Southern Nuclear Operating Company
Vogtle Electric Generating Plant Units 3 and 4 Combined License Application
Response to Request for Additional Information Letter No. 047
Physical Security Plan

Enclosure: Response to NRC RAI Letter No. 047 on the VEGP Units 3 & 4 COL Application Involving the Proposed Physical Security Plan

FSAR Section 13.6, Security

Draft PSP Figure 6

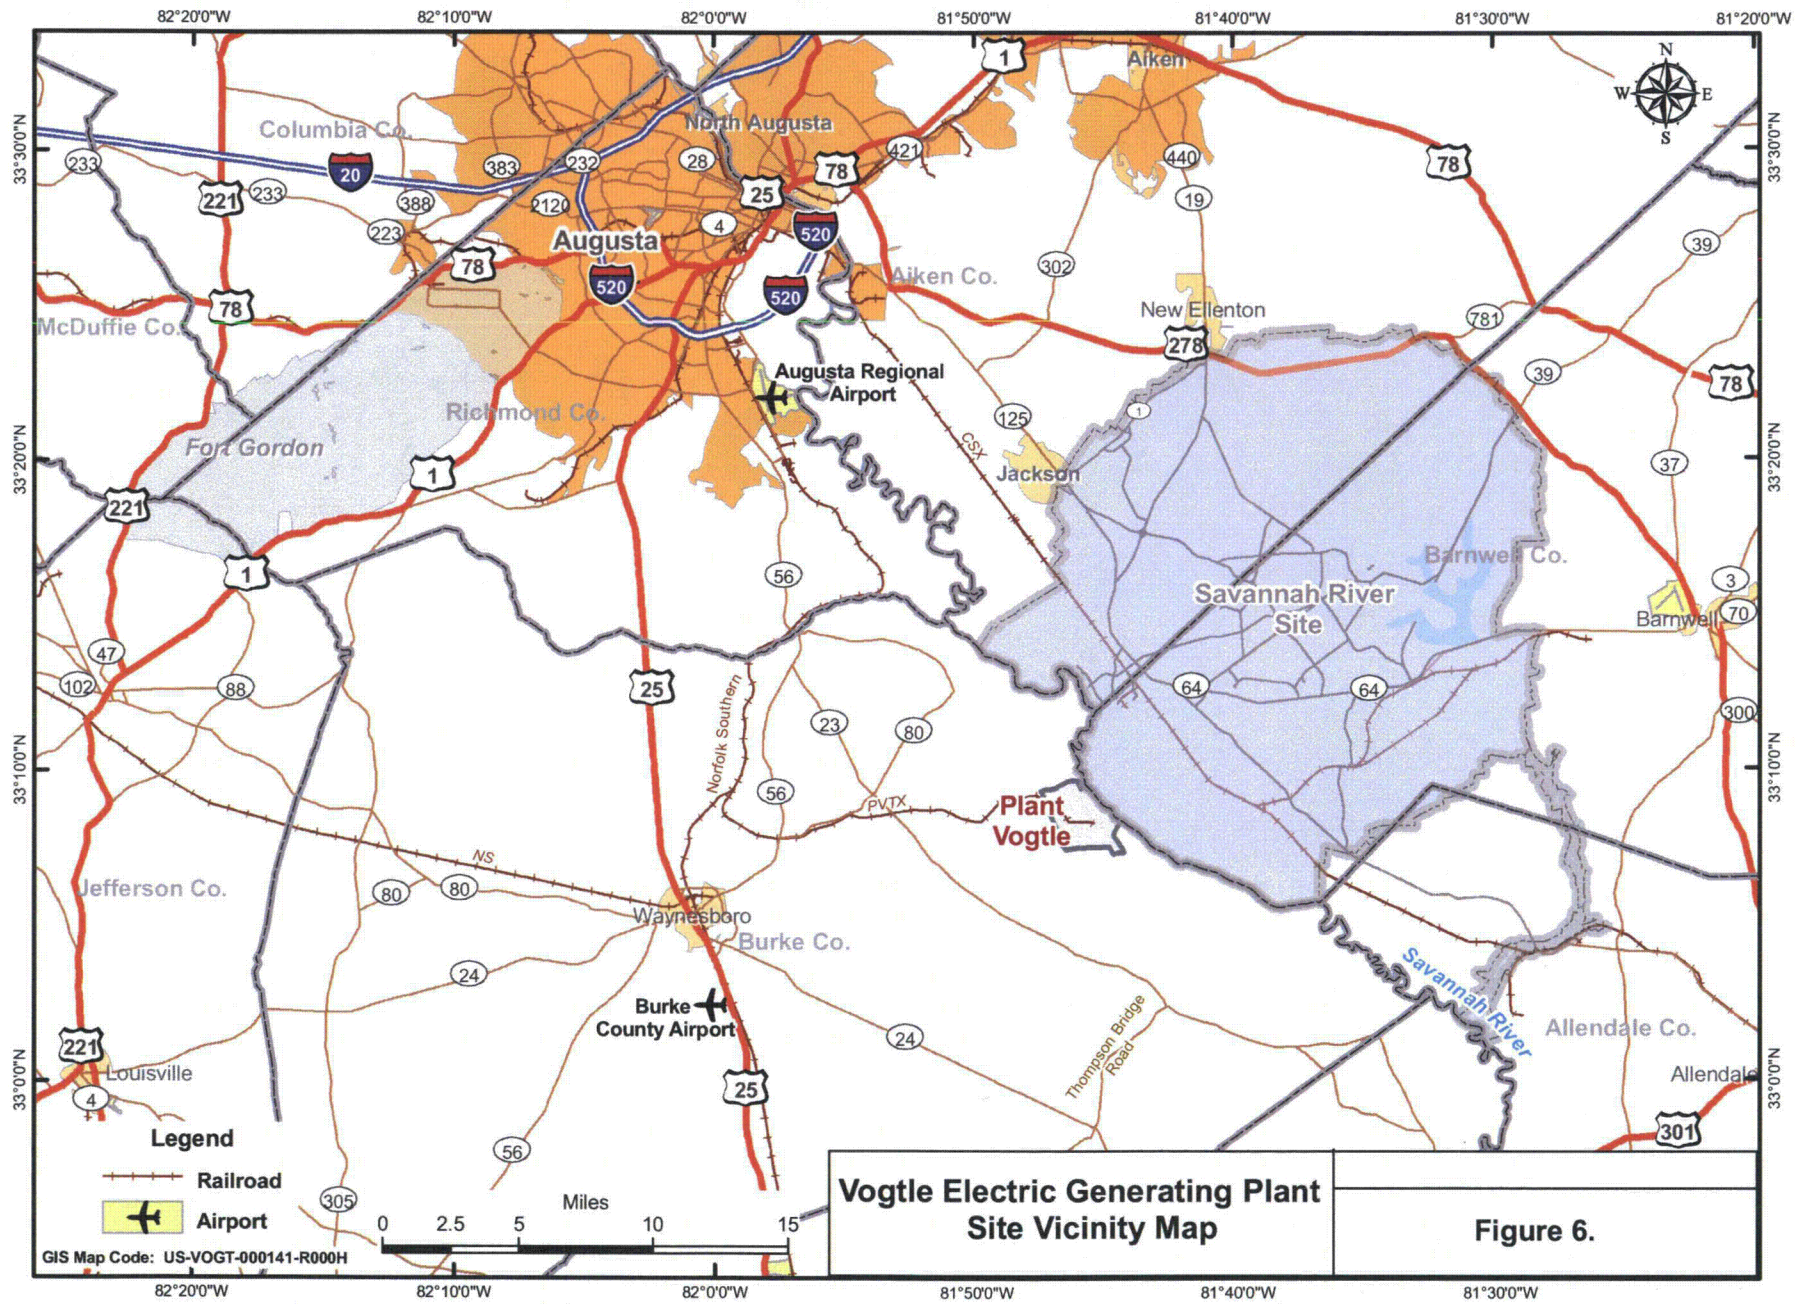
Physical Security Plan (revision 1), dated March 31, 2009, Appendix C, Safeguards Contingency Plan, Section 4.2. Page C-28. The level of detail identified in this section is inconsistent with the referenced section 1.1, and figures 6, 7, 8, & 9. NRC staff requests the plan and maps be updated to reflect the necessary information.

The required regulatory basis information will be incorporated into Section 1.1 of the PSP as indicated below. The Safeguards Contingency Plan will not be changed, because it references PSP Section 1.1. PSP Figure 6 will be revised to reflect any additional information that should be identified on this figure.

2. COL Application Part 8, PSP Figure 6, will be revised to incorporate the additional information that is added to Section 1.1, as depicted in Attachment 13.06-28 to this enclosure.
